AMENDMENT OF SOLICITATION/MODIFICATION OF CONTRACT	1. Contract Number DCAM-2010-B-0187	Page of Pages 1 | 1
2. Amendment/Modification Number **DCAM-2010-B-0187-002**	3. Effective Date 30-Oct-10	4. Requisition/Purchase Request No.
5. Solicitation Caption **ABRA Build-Out**

SOICITATION: DCAM-2010-B-0187
Build Out of Reeves Center 4th floor Space for ABRA.

RESPONSE TO OFFERORS QUESTIONS

DRAWING NO. F1.1
PROJECT NO. 09-039
DATE: DATE

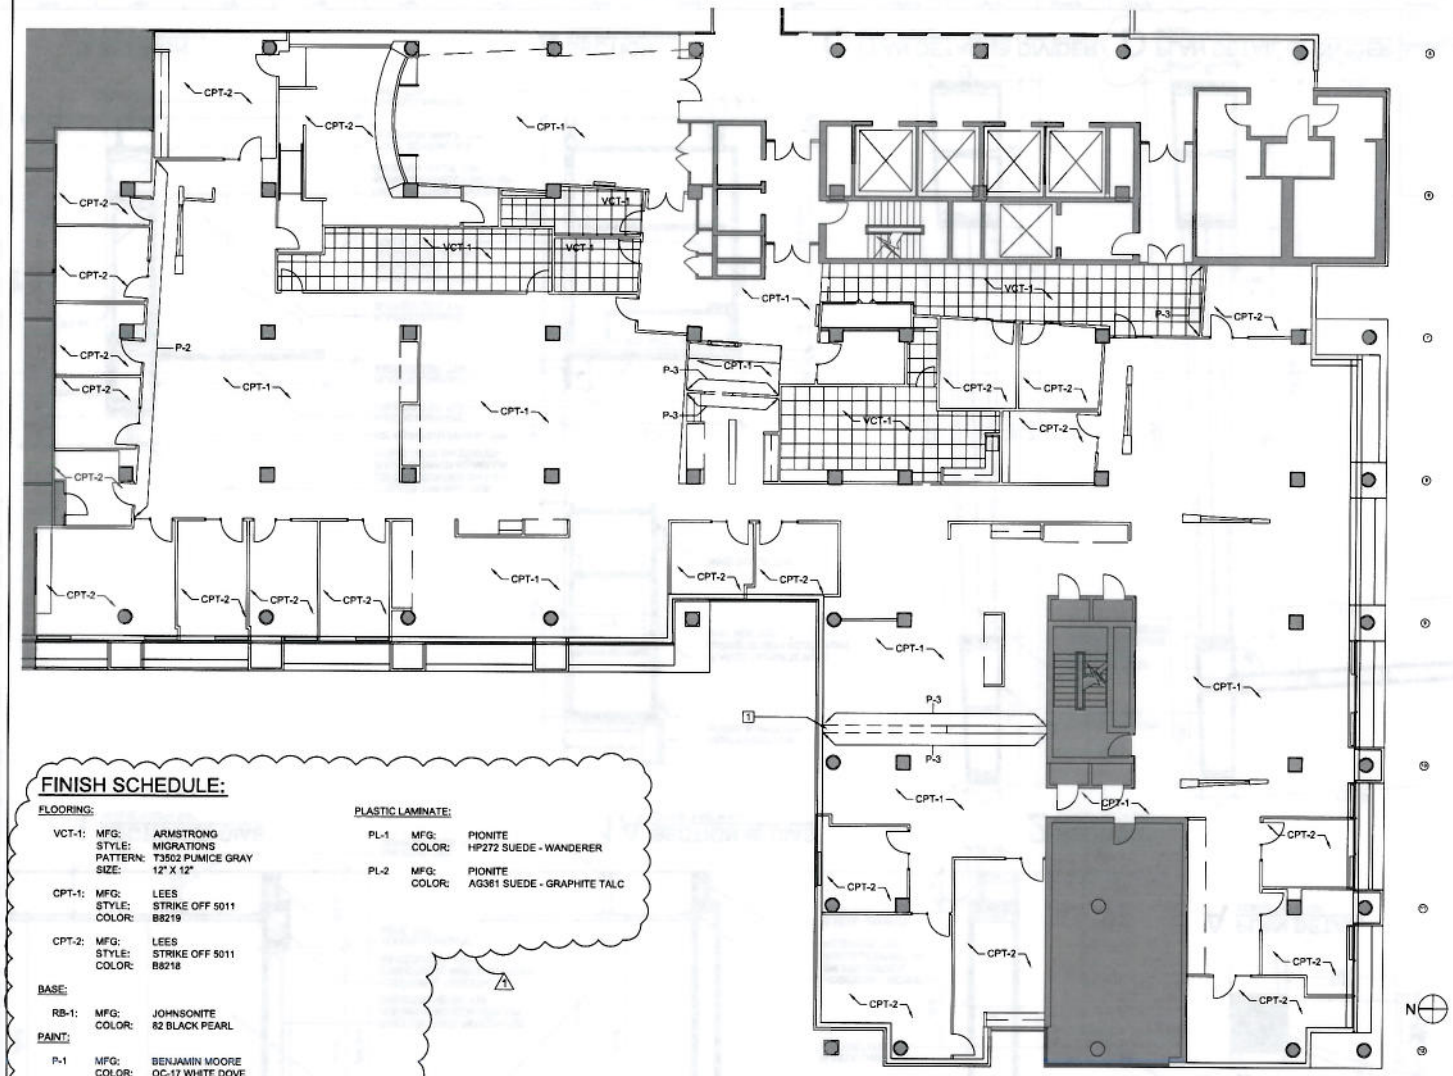
NO.	IFB SECTION	RFI #	Questions	Response
1			On drawing G1.1 in list of drawings for electrical has E-1 thru E-6 drawing listed but drawings we received has E-1 thru E-5 only. Please provide E-6 drawing.	There is no E-6 drawing.
2			On drawing D1.1 there is a general note for demolition but no details i.e. partition layout, reflected ceiling layout, light fixtures etc are not provided. Can you provide demo. Drawings with these details.	Sheet D1.1 shows the existing partition/workstation layout during the time of the survey. No demolition RCP is available. GC is responsible for verifying the existing conditions by visiting the site for developing the complete scope.
3			In the specs of both projects, Armstrong VCT 12" x 12" tile is specified…but the Finish Schedule has Norament Grano 925, which is listed under VCT-1. I am assuming you want the Nora but wanted to be clear, as the price difference is significant and can affect bids	Please refer to attached sheet F1.1 - Addendum 1 for revised finish schedule.

4			In the ABRA finish Plans, did you intend to have CPT-1 run throughout the elevator lobby area? It isn't clearly defined.	CPT-1 is not to run throughout the elevator lobby. CPT-1 will stop at the suite entry doors (2nd set of double doors from the lobby) and the Hearing Room double doors.
5			The carpet CPT-2 is slightly confusing. It is listed on the Finish Schedule as "COLOR BATH, 318 GRAVELING" . The carpet from Lees is actually "COLOR PATH, 318 GRAYLING". They do not have a color bath product. In addition..The product they do have is 12' rolls, not carpet tiles as specified in the Spec documents. I am not sure if you want the architect to change this? I will	Please refer to attached sheet F1.1 - Addendum 1 for revised finish schedule.

ARCHITECTURAL
DRAWING NO. A1.1
PROJECT NO. 09-039
BUILDING NO.
DATE: DATE
SHEET OF

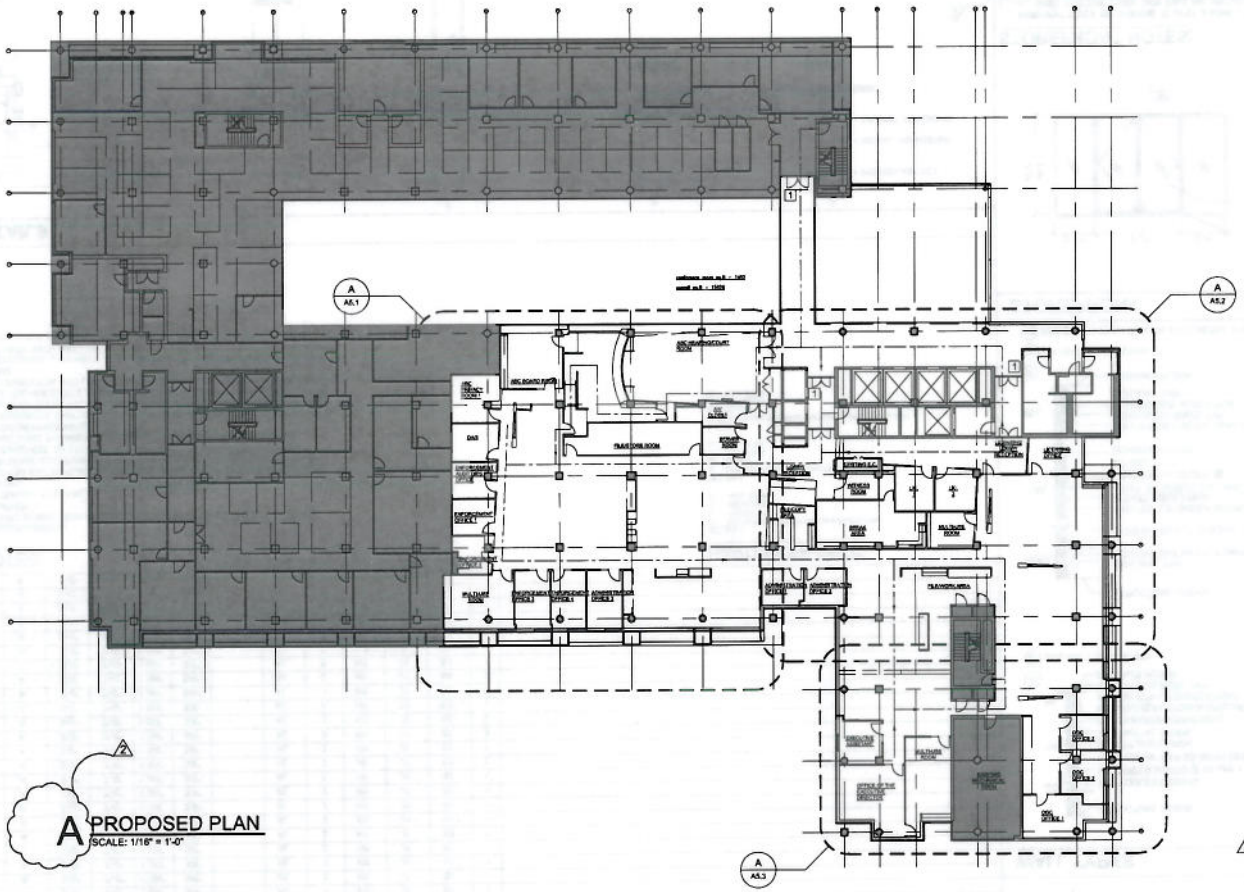
REVISION	DATE	DESCRIPTION	BY	APP.
	10.18.10	ADDENDUM #2 PERMIT COMMENTS		
	9.13.10	CLIENT MODIFICATIONS		
	9.23.10	PERMIT & BID
